# FALCON SERVICE BULLETIN

## FALCON 7X

**No 176**

**REPLACEMENT OF MGPL RIVETS UNDER THE  
UMBRELLA**

**Figure 7: LOCATION OF THE RIVETS**

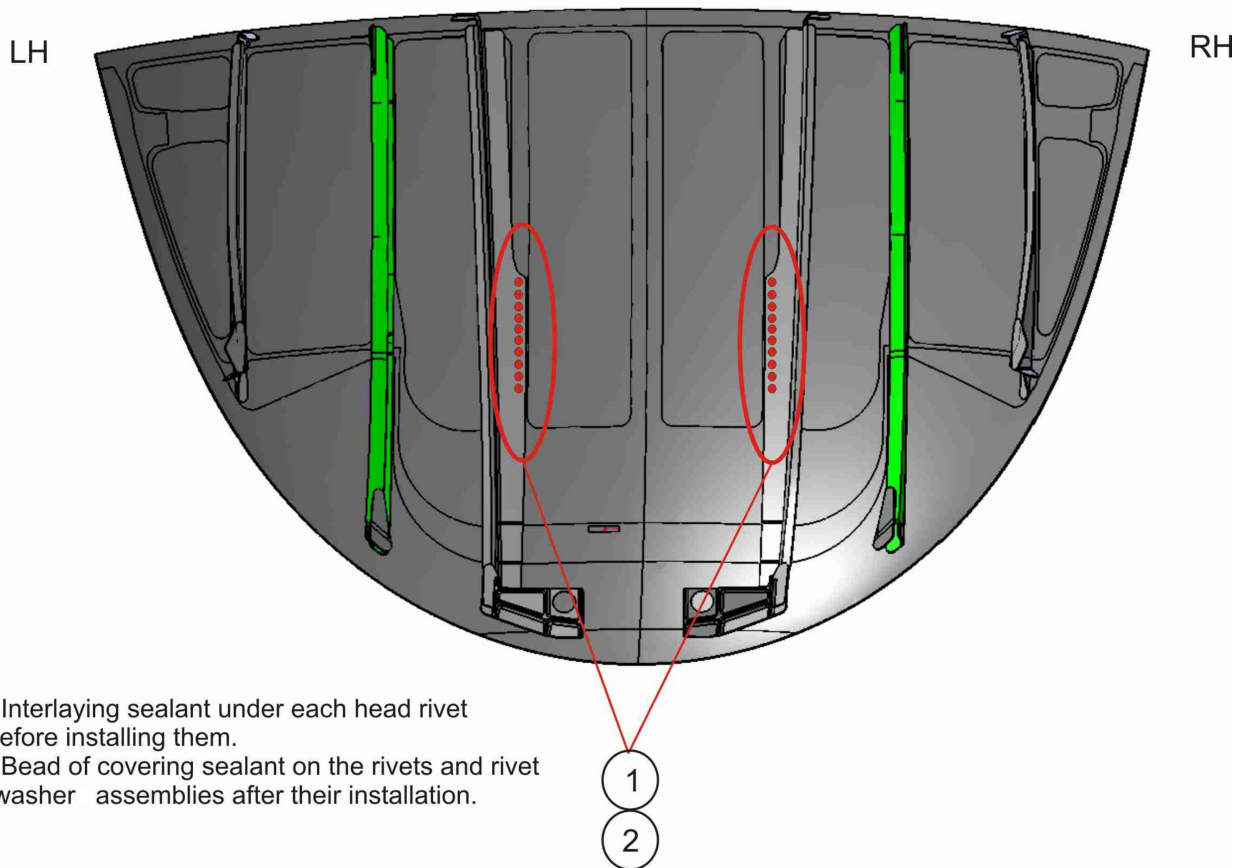
On the cockpit upper skin, the LH and RH stringers #3 have been assembled with MGPL rivets. But it has been noted that in the case of maximum certified bird impact, the cockpit upper skin deformation would lead to interference between the rivet shank and the CMOP.

The purpose of this Service Bulletin is to remove the risk of interference by replacing the MGPL type rivets with solid type rivets.

- removing twenty MGPL type rivets located on the cockpit skin panel,
- installing twenty solid type rivets.

- (1) Remove the twenty MGPL rivets (**fig. 7**).
- (2) Enlarge the twenty holes for rivets (1-fig. 7) (Refer to **SRM 51-40-03**), if necessary.
- (3) Apply a coat of **interlaying sealant** under each rivet head before installing them (Refer to **TASK 20-32-00-390-801**).

- (4) Install the twenty rivets (1-fig. 7) and their rivet washers (2-fig. 7) (Refer to **SRM 51-40-04**).
- (5) Inside the aircraft, on the twenty rivets (1-fig. 7) and rivet washers (2-fig. 7) assemblies, apply a bead of **covering sealant** (Refer to **TASK 20-32-00-390-801**).
